PIL #25-001

MBC2430 - New Push Rod Length

Subject: MBC2430 New Push Rod Length

Models: Meritor Red Brake Chambers (Parking & Service)

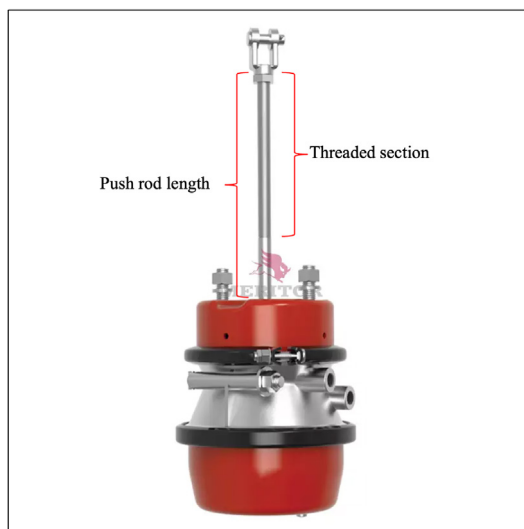
Meritor Australia (CDBS) is advising you of a product improvement implemented in our MBC2430 brake chamber. We have increased the total length of the push rod to suit all local trailer and truck applications.

Part Number	Thread Length	Push Rod Length
MBC3030	285mm	342mm
MBC2430	285mm	342mm
MBC2424	292mm	338mm
MBC3636	318mm	380mm

MBC2430 now matches the same length as MBC3030. There is no change in the service or installation procedures, or function of these brake chambers.
